City of Mississauga Department Comments

Date Finalized: 2021-11-17	File(s): A493.21 Ward 10
To: Committee of Adjustment	
From: Committee of Adjustment Coordinator	Meeting date:2021-11-25 1:00:00 PM

Property Address: 6770 Gracefield Drive

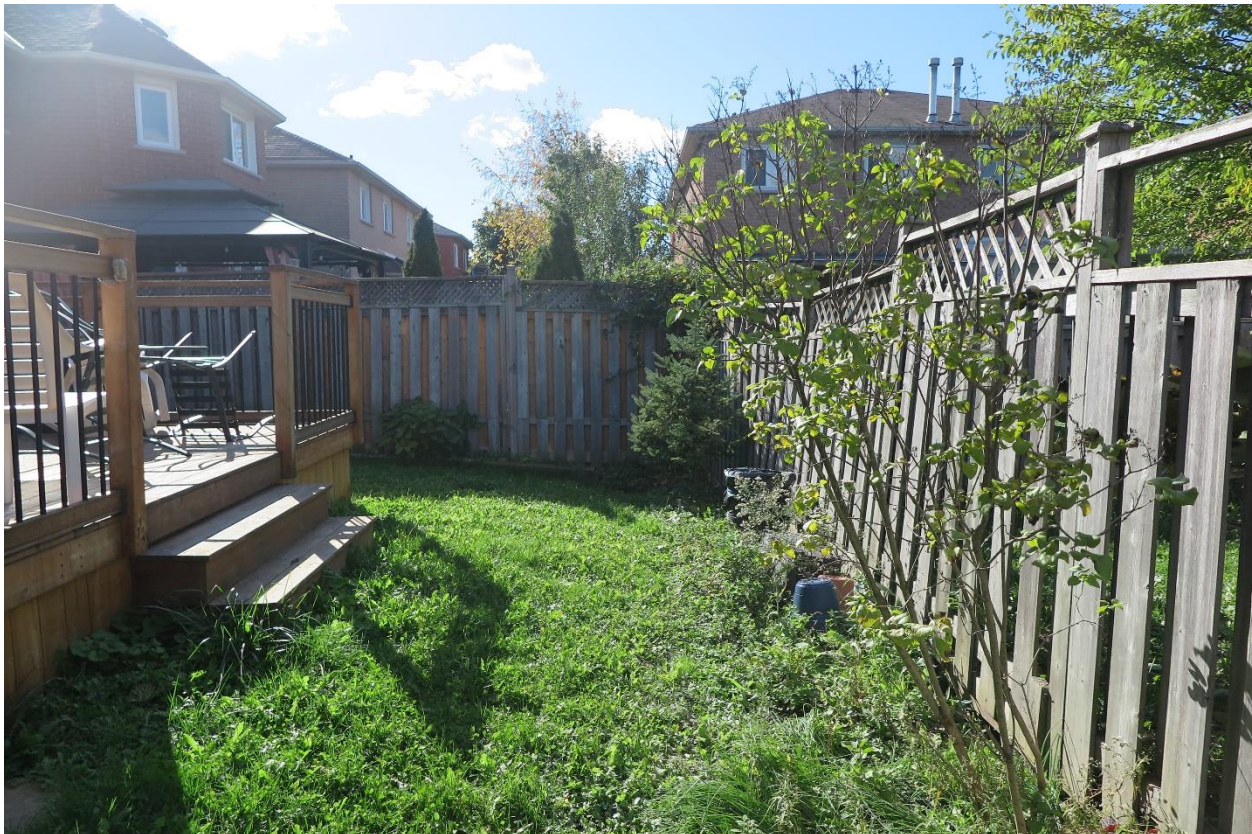
We are noting for Committee's information that any Transportation and Works Department concerns/requirements for the proposed addition will be addressed through the Building Permit process.

From our site inspection of the property we also note that there is a functioning catchbasin on this property and we foresee no drainage related concerns.
